NORTHERN LAND RECLAMATION REQUEST FOR AMENDMENT

TECHNICAL NOTE

NEW BRIDGEWATER BRIDGE

DOC NO: 2024-MCD-0000-REP-PRJ-00112
 CLIENT: DEPARTMENT OF STATE GROWTH
 PROJECT: NEW BRIDGEWATER BRIDGE PROJECT
 LOCATION: BRIDGEWATER, TASMANIA, AUSTRALIA
 PROJECT NO: 2024

Figure 2 – Extent of Proposed Amendment to Northern Land Reclamation

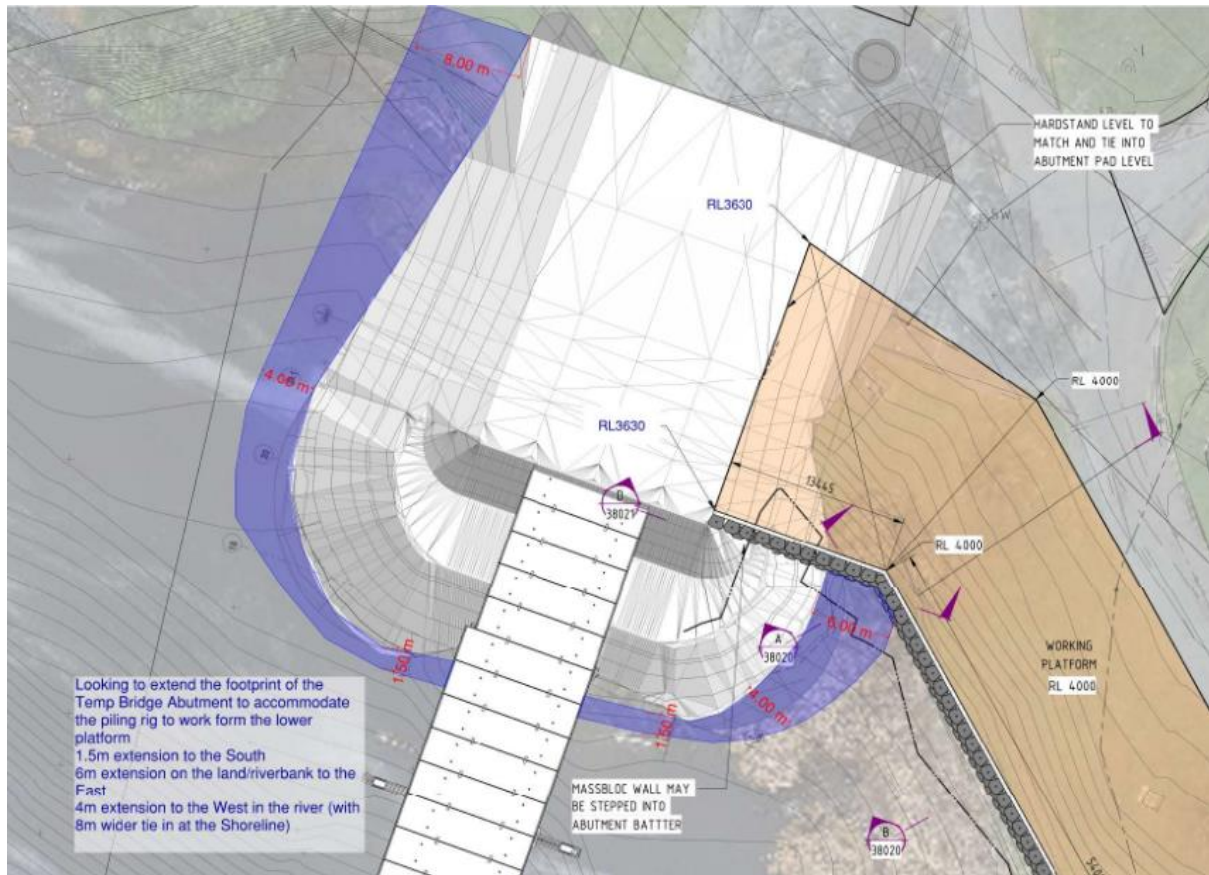
Figure 2 shows the proposed amendment to the current as-built northern land reclamation indicatively dimensioned over an aerial image captured in January 2023.

The key dimensions for the proposed amendment to as-built northern land reclamation are:

- Length along bridge centreline – $45\text{m} + 1.5\text{m} = 46.5\text{m}$.
- Maximum width – $45\text{m} + 14\text{m} = 59\text{m}$
- Maximum extent from shoreline – $15\text{m} + 1.5\text{m} = 16.5\text{m}$
- Gross area – $1,616\text{ m}^2 + 300\text{ m}^2 = 1,916\text{m}^2$
- Total area of land reclaimed above the high-water mark is $614\text{ m}^2 + 300\text{ m}^2 = 916\text{ m}^2$ (this remains less than the maximum $2,500\text{ m}^2$ allowed by Permit Condition 6.13).

- Short term stability under crane and vehicle loading necessary for construction of the New Bridgewater Bridge.
- Short term stability for scour protection in storm events, in return period periods up to 1 in 10 years.
- Minimise impact to existing shoreline to minimise changes in the river hydrodynamics. The maximum change in shoreline is $11.3\text{m} + 1.5\text{m} = 12.8\text{m}$ from existing at the highwater mark.
